ENSTROM HELICOPTER CORPORATION

SERVICE DIRECTIVE BULLETIN NO. 0108

1. SUBJECT: Cracked Pylons
2. MODEL: F-28F, 280F, and 280FX
3. EFFECTIVITY: All Serial Numbers
4. BACKGROUND:

Figure 1. Pylon (Viewed from Top)

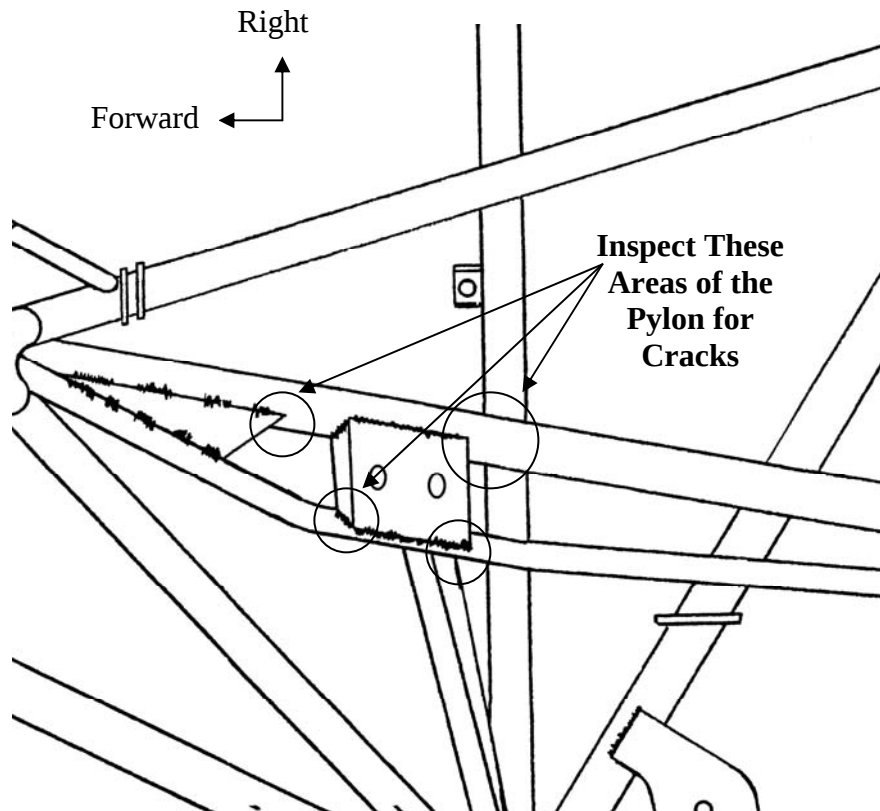
Enstrom recently received reports of 4 cracked pylons. The failures occurred in the area adjacent to the mounting bracket for the belt tension assembly bracket (Refer to Figures 1 and 2). Refer to Enstrom Service Information Letter SIL 0152 for additional information.

- A. Remove the cowling to gain access to the pylon in the area of the belt tension assembly.
- B. Using a 10-power glass, inspect the pylon area adjacent to the belt tensioning assembly mounting bracket and the gusset for cracks and other damage. (Refer to Figures 1 and 2).

- 1.) If no damage is found, continue to Step C.
 - 2.) If damage is found, contact Enstrom Customer Service for repair instructions and to report the aircraft serial number and time in service, and the serial number, part number, and manufacturer of the drive belt.

Figure 3. Flatness Inspection Criteria

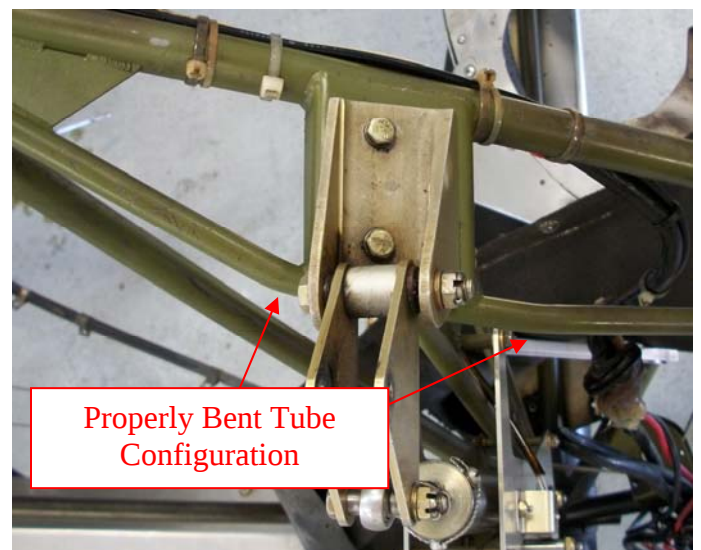
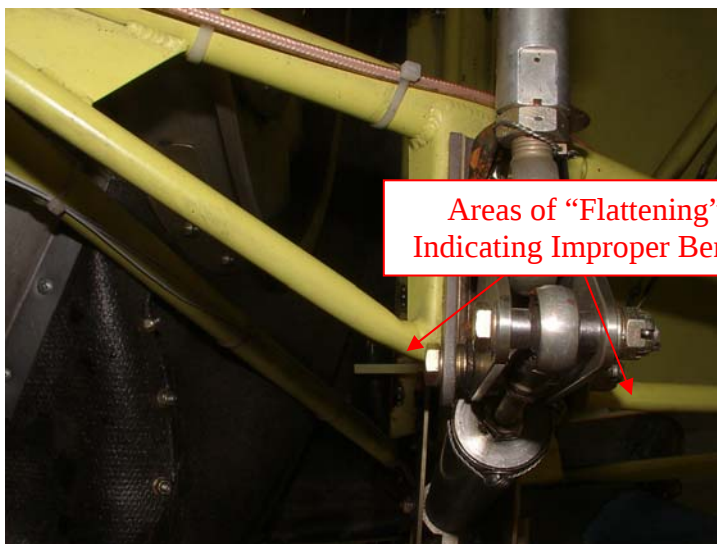
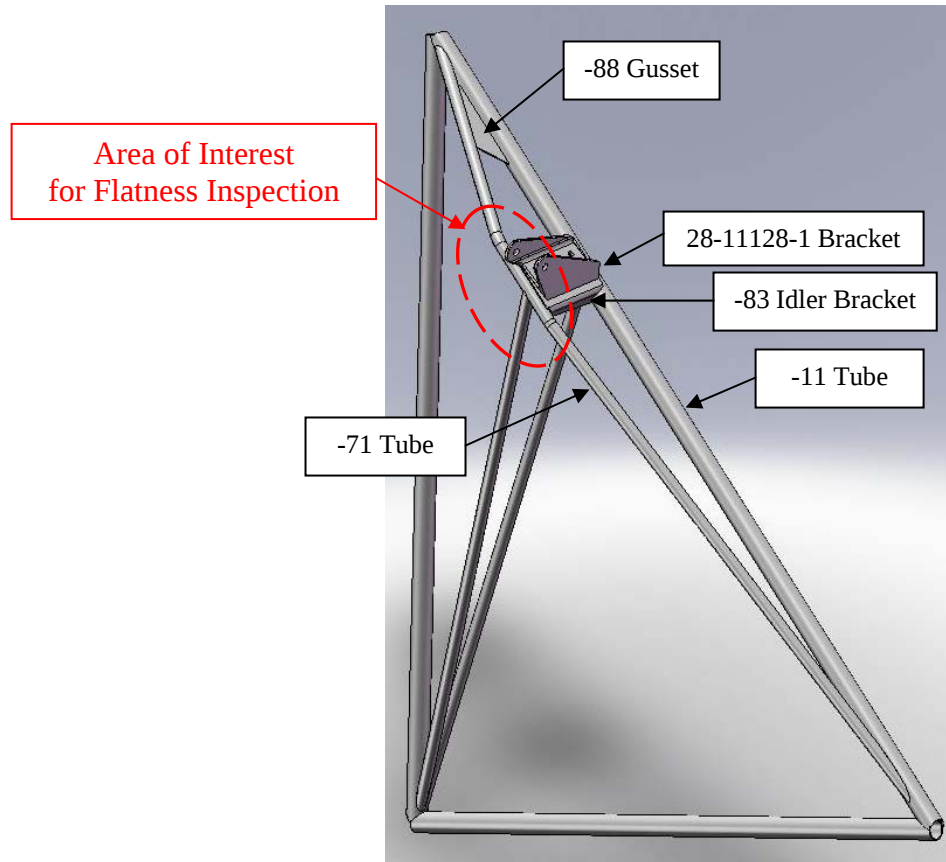
Enstrom has determined the cracked pylon tubes were assembled with improperly bent pylon tubes in two places. Figure 3 depicts improperly bent and properly bent tubes for reference. Flattening of the smaller tube is evident in both bends on the tube in the improperly bent configuration.

- C. Inspect the pylon tube in the area adjacent to the belt tensioning assembly mounting bracket for flattening in the bend (Refer to Figures 3 and 4).
